From: Oliveira, Marta
Sent: 07 June 2024 10:06
To: Osmond, Gary
Subject: RE: RM/24/96684 NETLEY FIRS, KANES HILL, SOUTHAMPTON, SO19 6AJ - landscape comments

Subject: RM/24/96684 NETLEY FIRS, KANES HILL, SOUTHAMPTON, SO19 6AJ - landscape comments

My comments below focus on the plan prepared by Deacon Design DD650 L01 (no revision - note: drawing for some reason not titled but I assume this is the detailed landscape plan?).

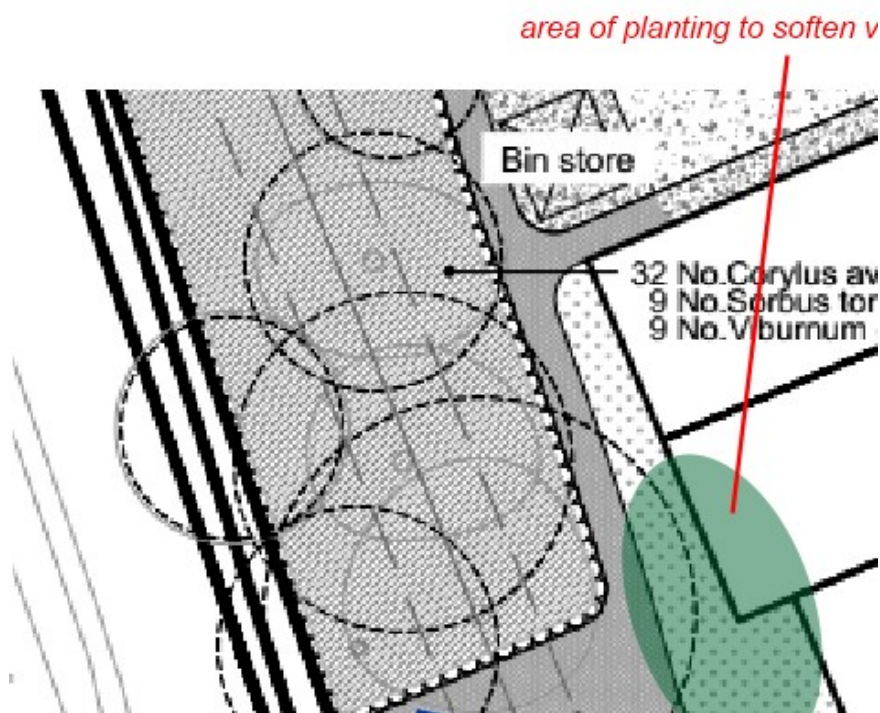
a/ The existing boundary vegetation along the frontage to Kanes Hill performs an extremely important role in screening the site. I am concerned that the notional symbol used to indicate the extent of this planting is too vague and may not reflect the on-ground situation. Looking at street view images on line there are considerable stretches of Rhododendron that perform an important year round screening role.

Please can we ask the designers to update the drawing to show the extent of existing vegetation more accurately, especially the understorey growth, so that any gaps/areas of thinner screening can be clearly shown on plan (this also applies to the boundary vegetation shown on the N & E of the site). This will then allow a more targeted specification of new screen planting in locations where it is most needed. This may require further survey work on site unless the existing topographical plan has already picked up the understorey accurately.

At present the notes on plan regarding this band of vegetation are too general and there is no way of assessing if the numbers of understorey planting allowed to fill gaps is sufficient or not. The species mix shown is curious. A % of evergreen screening plants should be included and some more obvious deciduous options such as Hawthorn. It would also be worth including a % of canopy tree species (especially Oaks) to ensure long term succession.

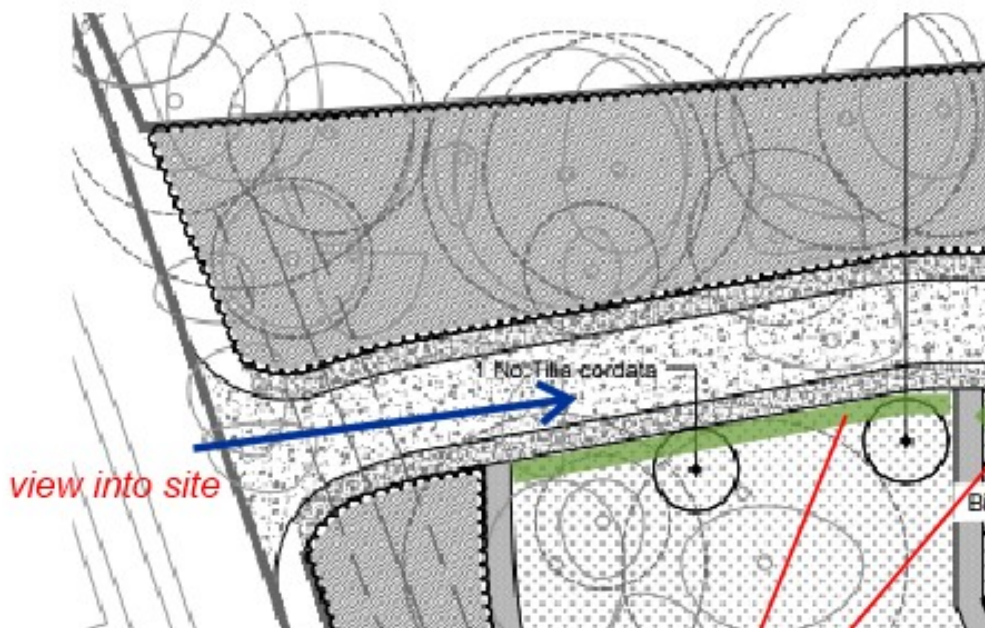
b/ The installation of a new link path onto Kanes Hill will open up a direct view into the site. An area of planting adjacent Units 6-8 will help reduce visual impact. This could be native understorey type planting or perhaps a mix of large evergreen shrubs.

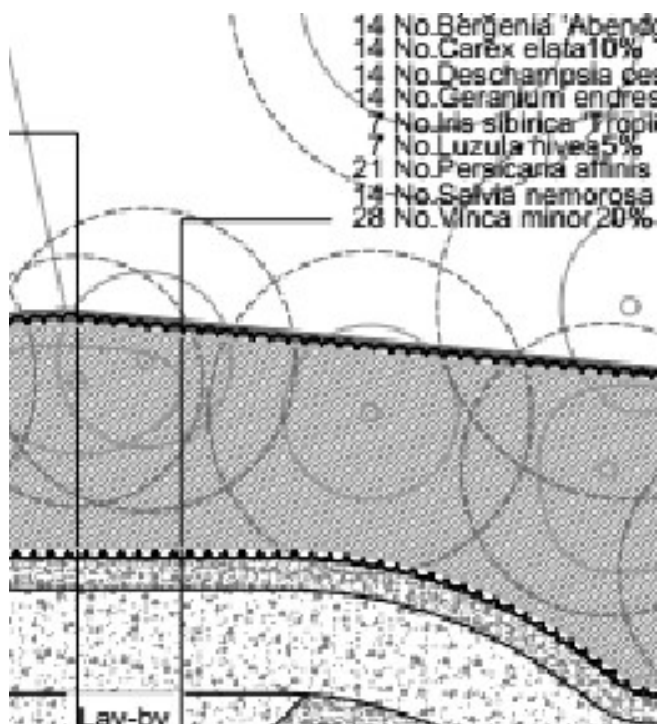
c/ A further oblique view into the site will occur down the driveway. Additional native mix hedge planting as shown below will help soften this view:
